# Work Order ID 90236

Item Name: Crosstube Mid Fwd

DART AEROSPACE LTD HAWKESBURY, ONTARIO, CANADA	
DRAWING NO. D206-667-147	REV. A SHEET 1 OF 4
TITLE CROSSTUBE ASS'Y (206L MID FWD)	SCALE NTS

DRAWING NO. D206-667-147	TITLE CROSSTUBE ASS'Y (206L MID FWD)	REV. A	<b>DART AEROSPACE LTD ENGINEERING ORDER</b>		D.E.O. NO. D206-667-147-A-1	SHEET NO. SHEET 1 OF 1	SCALE NTS
DRAWN <i>q</i>	CHECKED <i>ASS</i>	MFG. APPR. <i>JB</i>	APPROVED <i>MD</i>		DE APPR. <i>MD</i>		
DATE 11.07.15	DATE 11.07.20	DATE 11.07.21	DATE 11/07/21		DATE 11.07.21

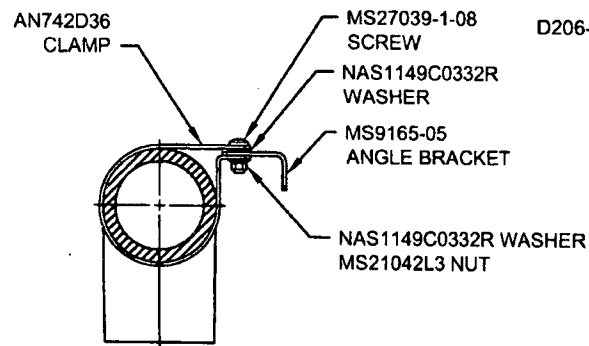
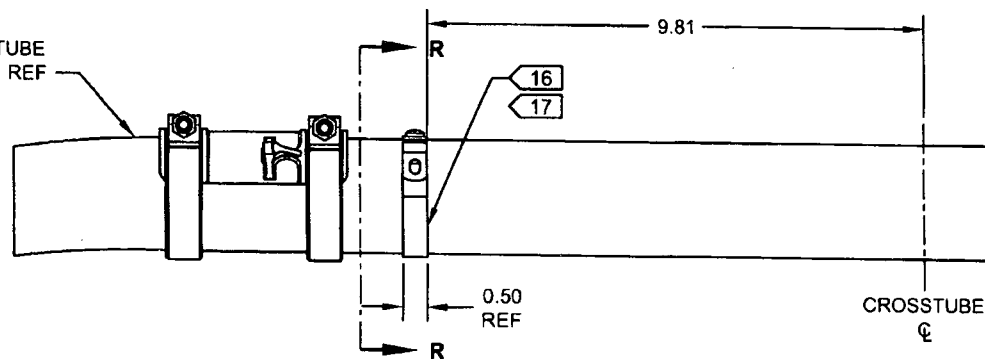
**PURPOSE:**

ADD ELECTRICAL GROUNDING STRAP

ITEM	QTY -147	PART NUMBER	DESCRIPTION
1	X	D206-667-147	CROSSTUBE ASSEMBLY (206L MID FWD)
10	2	AN742D36	CLAMP
11	2	MS9165-05	ANGLE BRACKET
12	2	MS21042L3	NUT (OR MS21042-3)
13	2	MS27039-1-08	SCREW
14	4	NAS1149C0332R	WASHER (OR AN960C10L)

- 16) MASK AREA UNDER CLAMP PRIOR TO PAINTING  
 17) SEAL EDGES WHERE AN742D36 CLAMP MEETS WITH THE CROSSTUBE USING SIKAFLEX-241/-291 OR MIL-S-8802 CLASS B2 OR PROSEAL 890 SEALANT  
 18) PERFORM RESISTANCE CHECK TO ENSURE MAX RESISTANCE IS 10 MILLIOHMS
